Brockville Main Sewage Pumping Station

ADDENDUM NO. 2

June 3, 2026

1
E22
SITE LIGHTING PLAN
 SCALE: 1:150

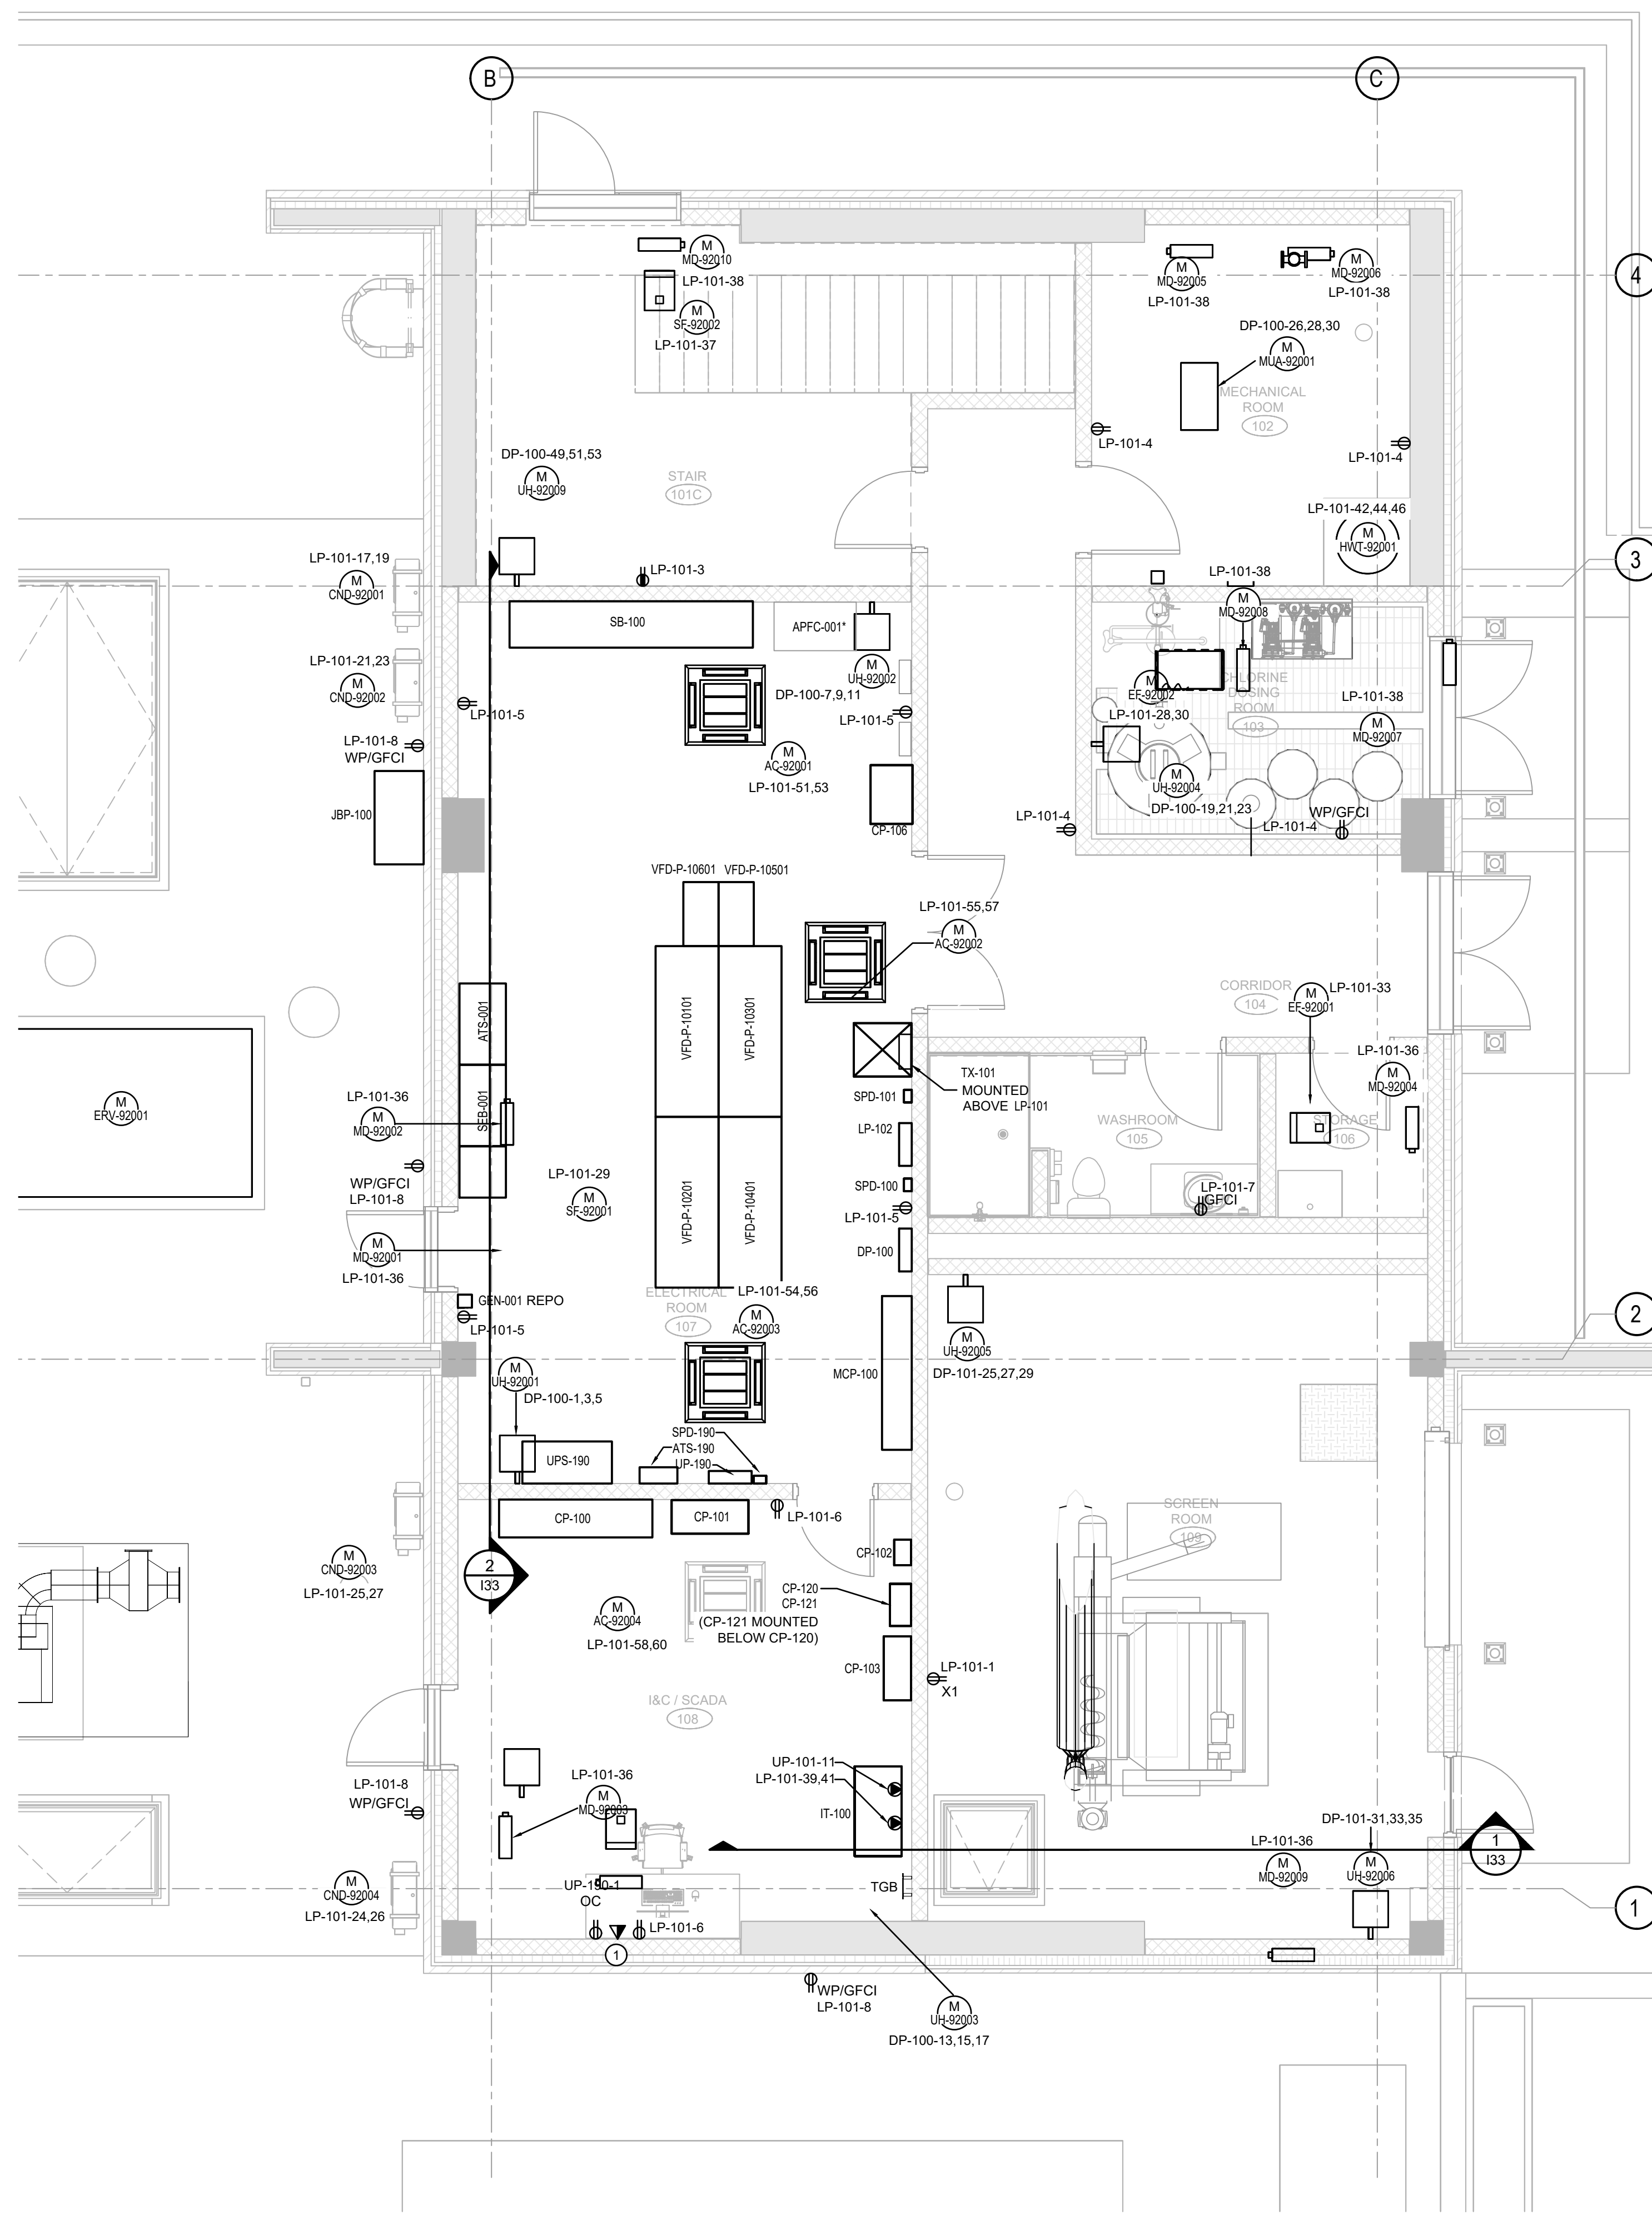
20.1 REPLACE entire drawing with the attached revised drawing E22. Drawing revisions include the following:

- .1 REPLACE Existing Drawing Notes to clarify control requirements.
- .2 REPLACE Type P1 Luminaires with new Dimmable Linear LED.REPLACE 3 x type O1 Luminaires on West Façade of pumping station with type O2 Luminaires.
- .3 REPLACE 1 x Type O2 Luminaire on East Facade with Type O1 Luminaire.
- .4 ADD 2 x Type O1 Luminaires to the South Façade of the pumping station
- .5 ADD 3 x Exterior rated Motion Sensors (Aimable) for control of exterior wallpack lighting within the gated area.
- .6 ADD Note for contractor to provide conduit penetrations through bottom of overhangs as indicated. Terminate in new interior junction box. Cap and weatherproof exterior ends for future CCTV by others. (typical of 5)

GROUND FLOOR LIGHTING PLAN
SCALE: 1:50

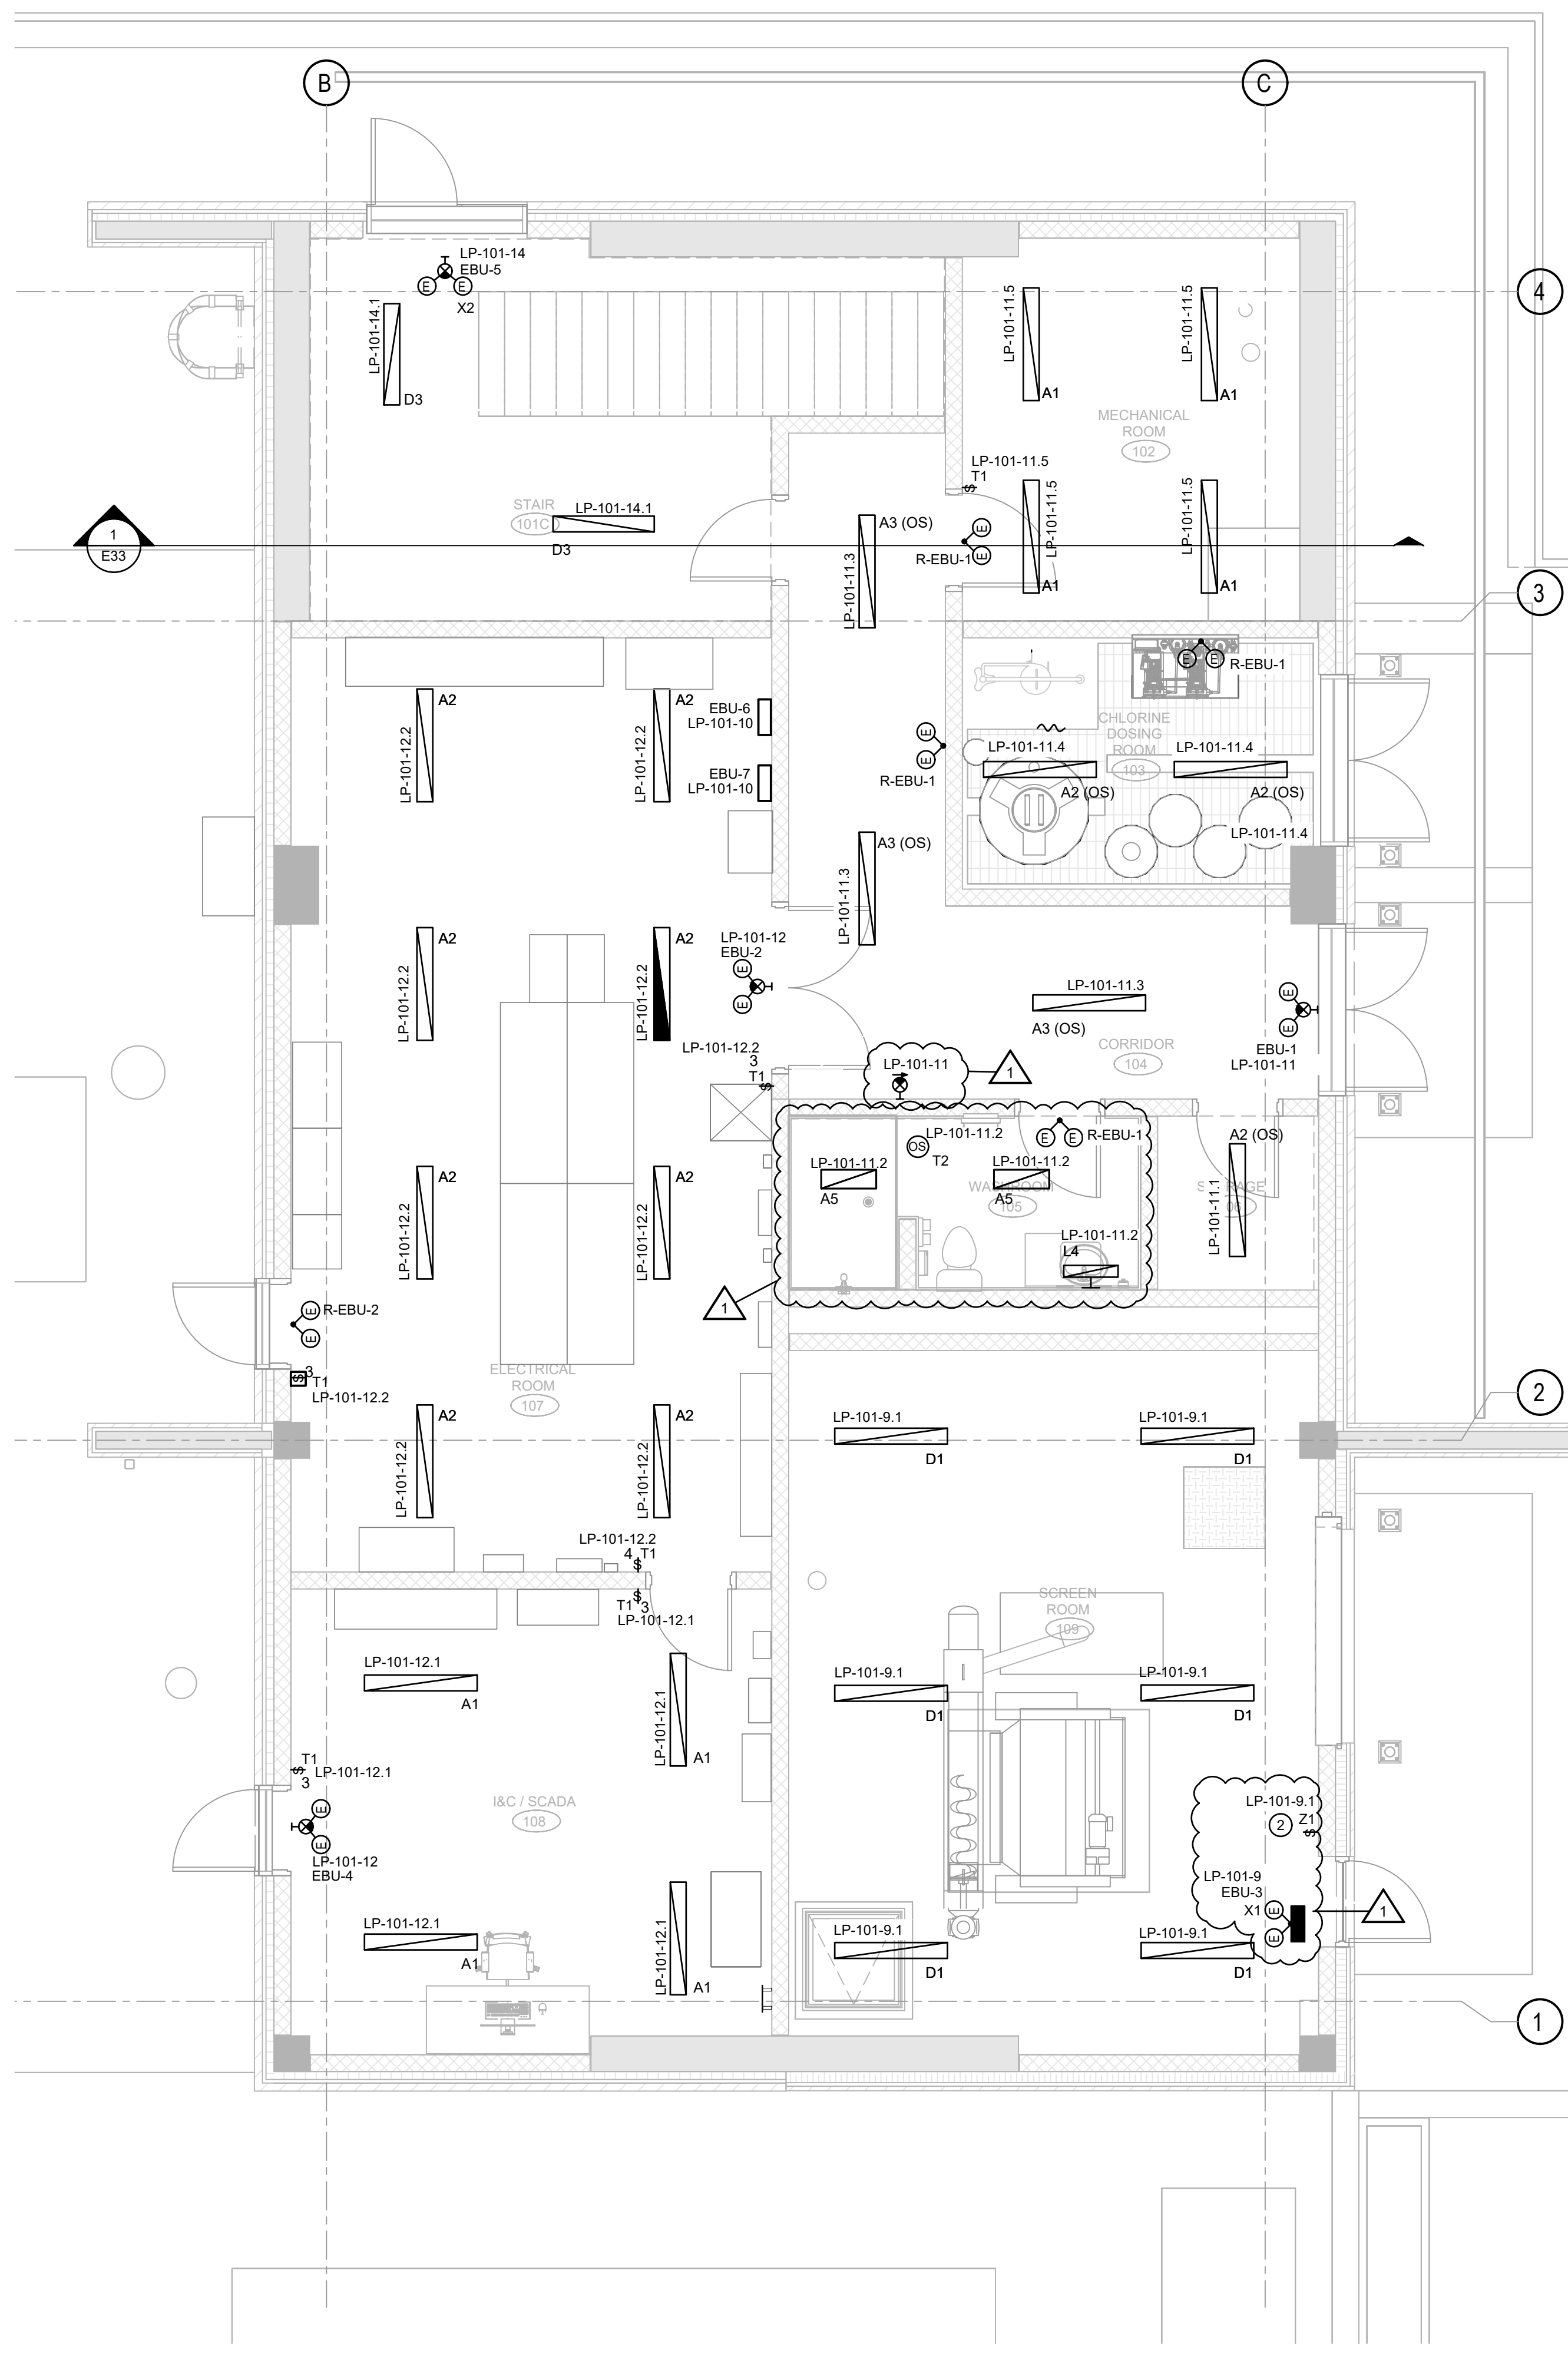
21.1 REPLACE entire drawing with the attached revised drawing E32. Drawing revisions include the following:

- .1 REPLACE 2 x Type C1 Pendant type Fixtures with 2 x NEW type A5 Linear LEDs
- .2 ADD Drawing note 2: "PROVIDE ZONE 1 RATED LIGHT SWITCH COMPLETE WITH PADLOCK PROVISION TO PERMIT LOCKING IN THE "ON" POSITION. PROVIDE LAMACOID NAMEPLATE IDENTIFYING: "WARNING – SWITCH ALSO CONTROLS WET WELL LIGHTING."
- .3 REPLACE Zone 1 Combination Exit Sign / Emergency Light in screen room with Zone 1 Emergency Light and Battery Unit In screen room.
